Application for Works Approval

Works Approval Number W6754/2022/1

Applicant Horizon Minerals Limited

Premises Cannon Gold Project
City of Kalgoorlie Boulder

Figure 2: Schematic diagram for water abstraction and transfer

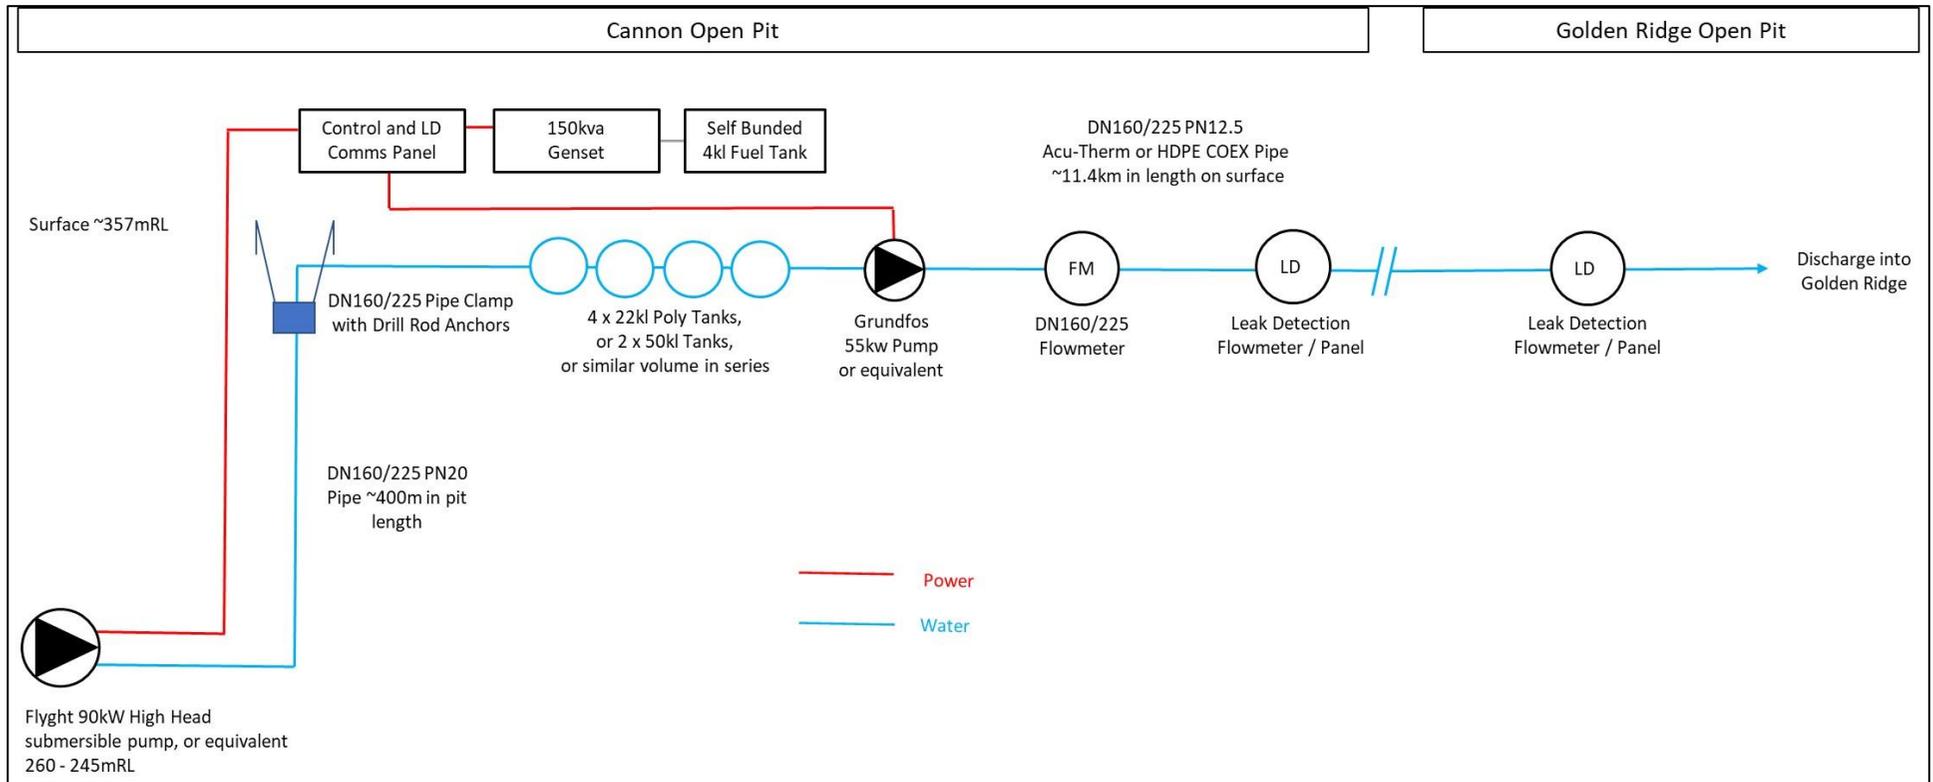
Page 3 Figure 2	Schematic diagram for water abstraction and transfer. Applicant commented stating that "2 x 50kL tanks in lieu of 4 x 22kL tanks may be utilised, or a similar approximate volume."	Noted the proposed changes. Section updated with a new schematic diagram that include all the proposed changes.
	"in addition to constructing the pipeline with DN160 PN12.5 Acu-Therm pipe, the pipeline may also be constructed with HDPE COEX in lieu of Acu-Therm, and DN225 sized pipe."	
Page 7	Reference Error.	Noted and updated the section with the correct reference.
Page 8 Section 3.2.1	Typographical error – "Lake Tindarlgooda" should be corrected to "Lake Yindarlgooda"	Noted and corrected accordingly.
